Attachment 2
EPA Response to Comments

Response to Comments for the National Pollutant Discharge Elimination System (NPDES) Permit No. MA0003557 – Pilgrim Nuclear Power Station (PNPS), Plymouth, MA

Figure 1. Schematic of a Beaudrey WIP Screen. (Source: Beaudrey).

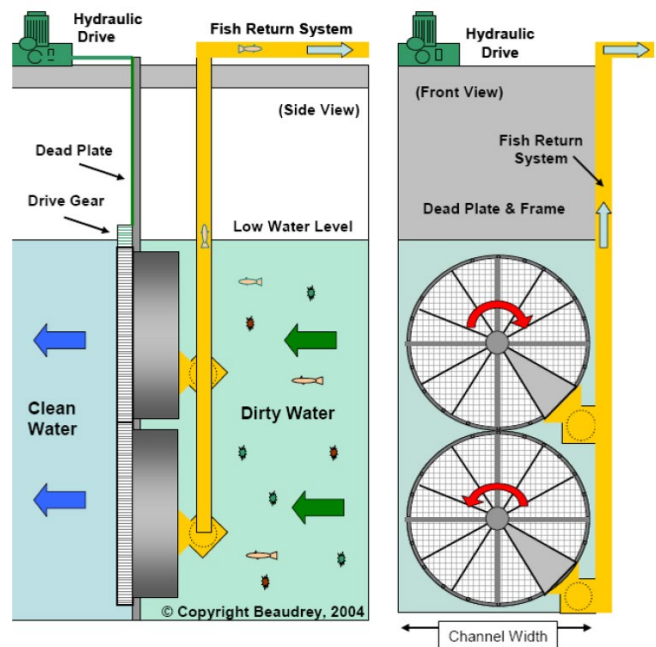
Finally, the commenter asserts that other available technologies to reduce impingement and entrainment at PNPS, such as the Beaudrey Water Intake Protection (WIP) screen or modified traveling screens, were not fully considered. WIP screens are designed with large disks divided into pie-shaped wedges that rotate around a center axle perpendicular to the intake flow (Figure 1). A stationary suction scoop mounted over one section of the disk vacuums debris and organisms as each wedge rotates under the scoop. A fish-friendly pump transports the organisms and debris to a return trough. *See* AR-717 at 2-7. This design eliminates "carryover" because the screen face, vacuum, and pump are all located on the same side of the screen. The screen material is designed to minimize impacts and organisms remain submerged for the duration of impingement and transport to the source water body. The commenter supports this technology, noting that the WIP screen "appears to achieve improved results to reduce mortality from impingement and entrainment and is capable of handling velocities of 0.5 fps." The comment states that the WIP screen's fish return system is gentler than the traveling screen and backwash system and that studies have observed benefits to species found at PNPS.²⁶

design, the WIP screen has a smaller dimension than the conventional traveling screen (see Figure 1). If the same number of screen bays are replaced with the WIP screens, the through-screen velocity will increase because the flow rate will be withdrawn through a smaller screen area. If PNPS were to install WIP screens without increasing the existing through-screen velocity (or to achieve, as the comment suggests, through screen velocities of no greater than 0.5 fps), the existing intake structure would have to be expanded to accommodate additional screens. Similarly, because the screen mesh affects the velocity, decreasing the mesh size of WIP screens to exclude early life stages of marine fish (e.g., less than 1 mm) would also necessitate additional screens to accommodate the required cooling water volume, which would require expansion of the existing intake structure. Expanding the intake structure would be more costly and would likely add a significant amount of time to the project as compared to simply installing new WIP screens in the existing bay. From a technical standpoint, while a WIP screen may be feasible for PNPS, it is not likely that it would meet the BTA requirements indicated in the comment without significant expansion of the CWIS. Moreover, the technology is not as effective as reducing impingement mortality and entrainment as the flow and intake velocity BTA requirements that can be achieved with the flow reductions associated with the shutdown.
